# **Sydney Metro West**

Hunter Street West Over Station Development  
Addendum to Transport and Access Report

Document Number: SMWSTEDS-SMD-SCB-SN100-TP-RPT-044009

The City of Sydney has provided comments on the Environmental Impact Statement submitted for the Concept State Significant Development Application (SSDA) relating to the Over Station Development (OSD) at Hunter Street West.

Figure 1 Comparison of driveway access at Hunter Street

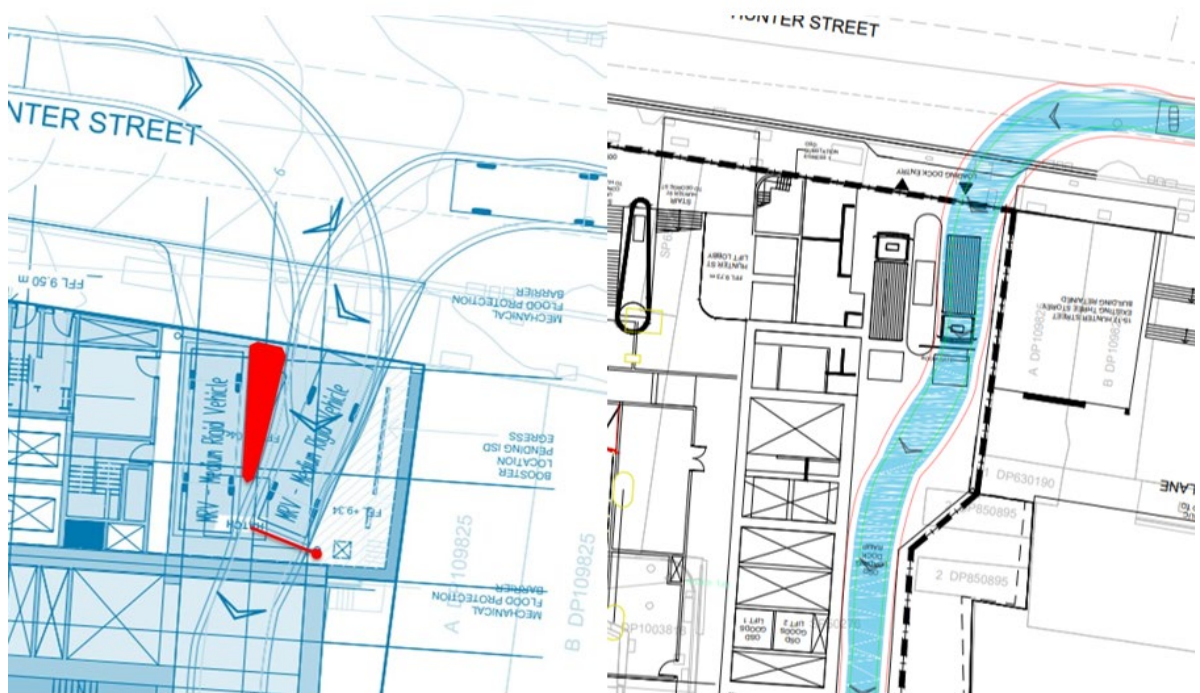
The reference design shows a two-way driveway crossing the Hunter Street footpath, with very wide splayed kerbs. Any driveway should be perpendicular to the kerb to minimise impact on the pedestrian footpath. The drawings also need to be updated to reflect the closure of Hunter Street at George Street i.e. left turns out of the driveway are not required.

Swept path analysis has been updated to show right only exit in response to the objectives of the City North Public Domain Plan (Appendix A).

Both the exit and entry movements from the site can be perpendicular to the kerb at the footpath crossing, as shown in Figure 1.

Detailed driveway design will be confirmed at Detailed SSDA.

**Figure 2 2026 Comparison of Fruin and Walking Space Guide Criteria**

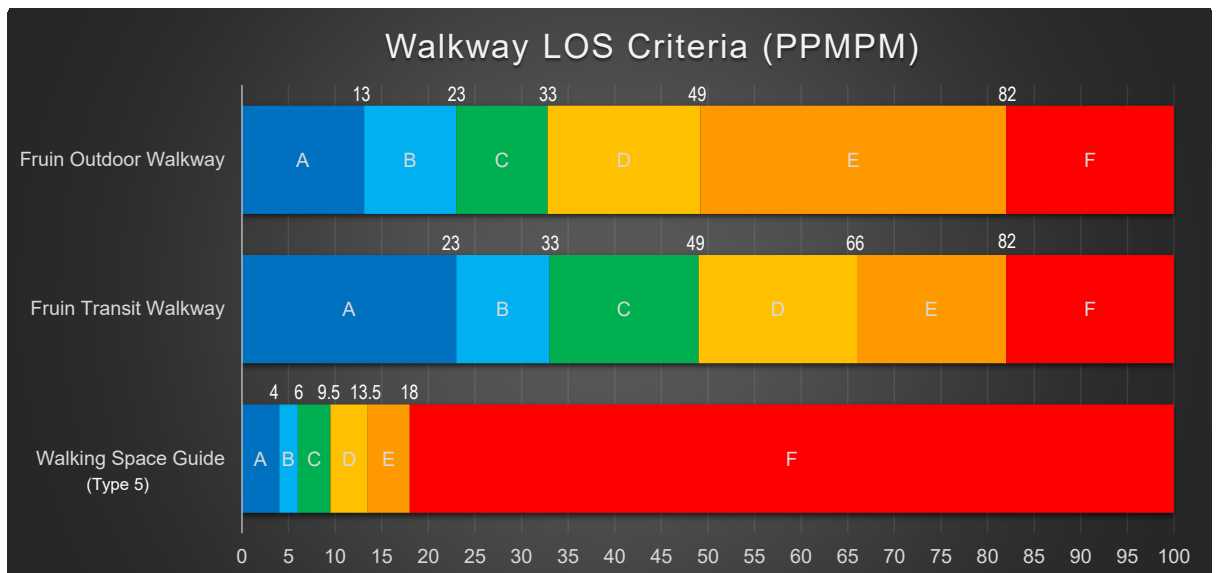
The City strongly objects to the use of Fruin for assessing footpath performance on Hunter Street and surrounds. This is an issue that the City has raised multiple times in previous submissions on the State Significant Infrastructure applications as well as during consultation meetings with Sydney Metro.

The City reiterates that the Walking Space Guide (WSG) published by TfNSW in 2020 at <https://standards.transport.nsw.gov.au/search-standard-specific/?id=TBA%20-%200003173:2022> is appropriate NSW standard for footpaths external to buildings in the public domain. It is misleading to imply that these footpaths are 'interchanges'. This leads to an under provision of walking space, crowding issues and safety concerns.

Sydney Metro argues that TfNSW's WSG is not fit for purpose as it shows poor performance for current conditions. The City's disagrees with this and is an accurate representation of existing conditions and a reason for intervention and road space reallocation, not a reason to ignore the issue by using a metric more suited to crowded station conditions.

The proposal used the Fruin Outdoor Walkway Criteria to assess footpath performance. Nearly all footpaths are forecast to operate at LOS C or better using this performance criteria. The exception is the southern footpath of Hunter Street, west of Pitt Street. This section would operate at LOS D, with or without SMW, or this OSD. The Fruin Outdoor Walkway criteria used is standard practice and considered appropriate for assessing conditions around a metro interchange.

We understand that the City of Sydney is requesting a reassessment of the footpath performance using the Walking Space Guide (WSG) criteria. This aspirational criterion is significantly more onerous than the Fruin criteria and may be more appropriate when applied to a greenfield development context. A sample comparison of the Fruin Walkway scales and the WSG, for Type 5 walkways, is provided in Figure 2.

Appendix A Swept path analysis

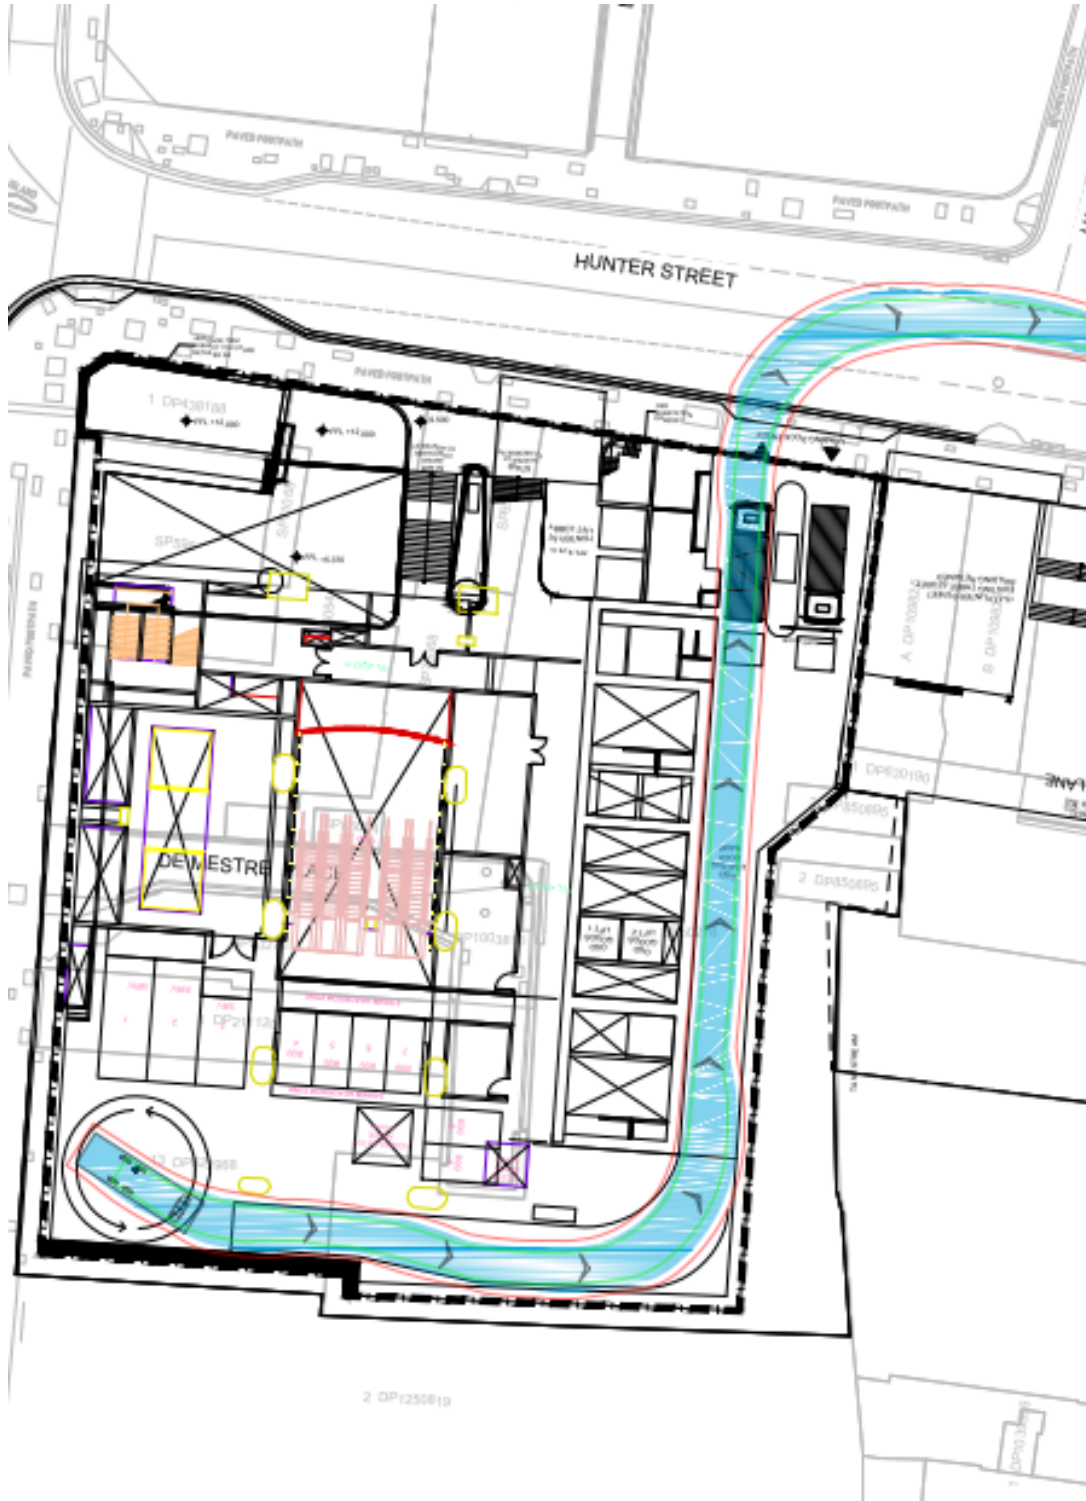
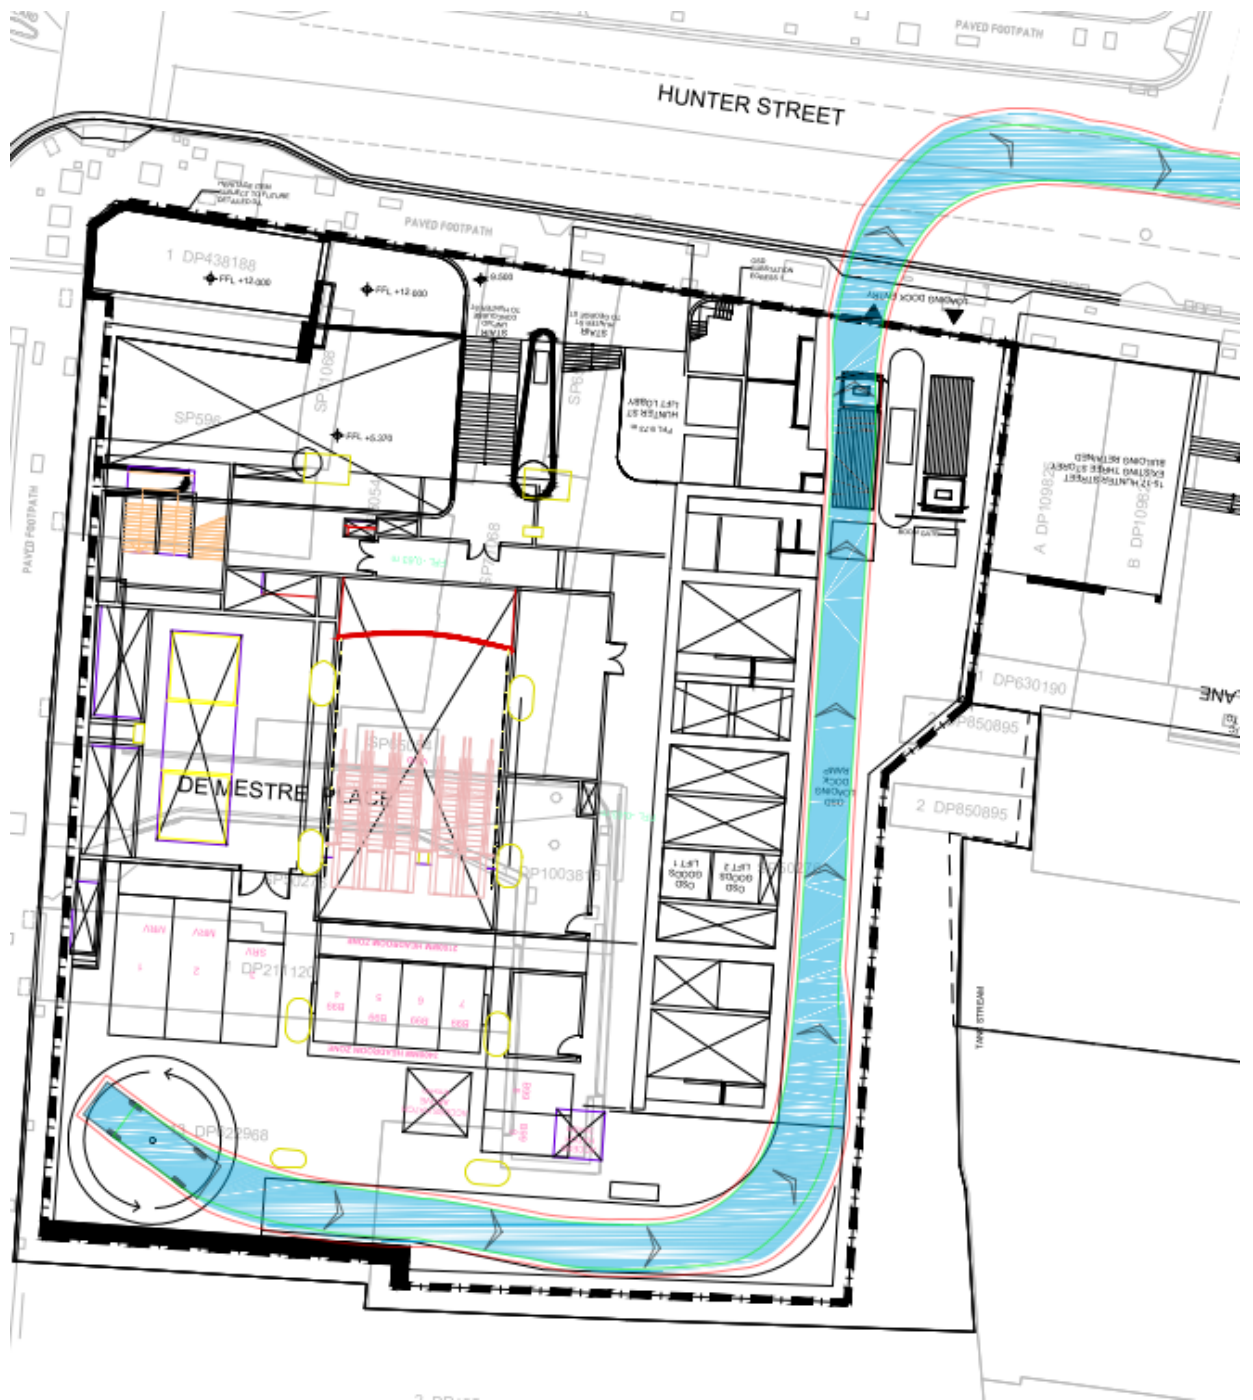
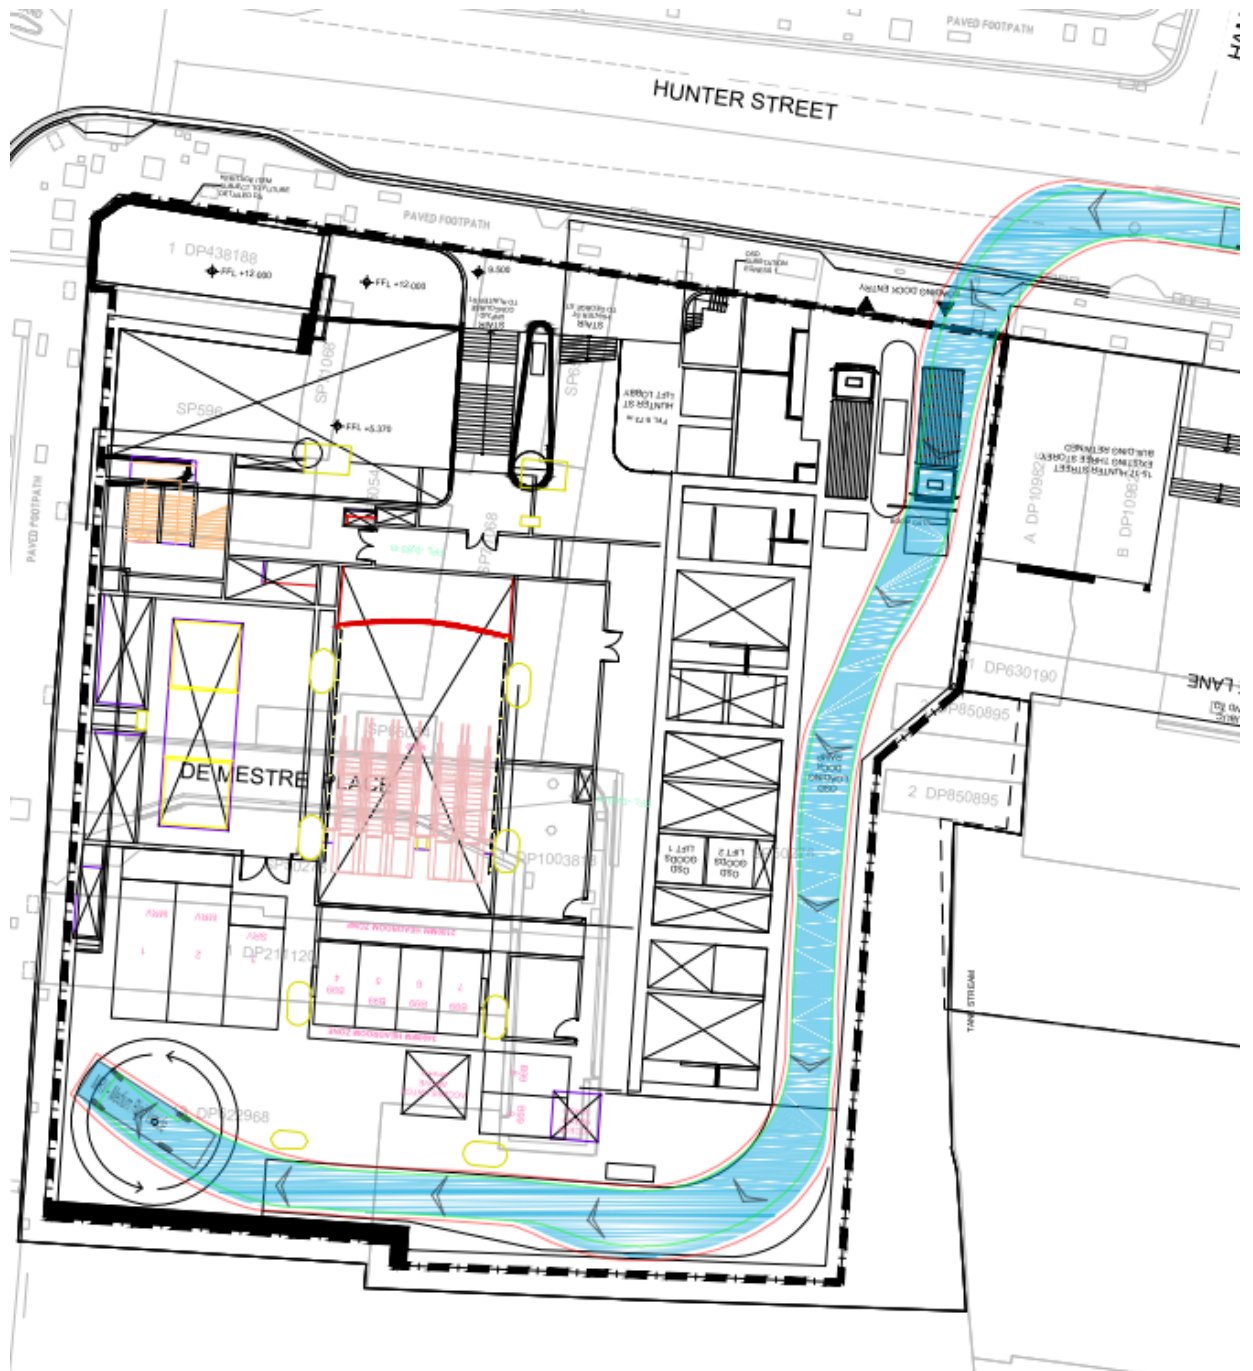
Section 5.2.3 Vehicular Access of the Transport and Access Report should acknowledge that Hunter Street is now closed at George Street, so the anticipated vehicle access movements are unlikely.

We have considered the vehicular impacts at Hunter Street. Revised swept path analysis for the operation of the OSD has been completed to acknowledge George Street closed to through traffic and Hunter Street closed east of the George Street intersection. This has been included in Appendix A.
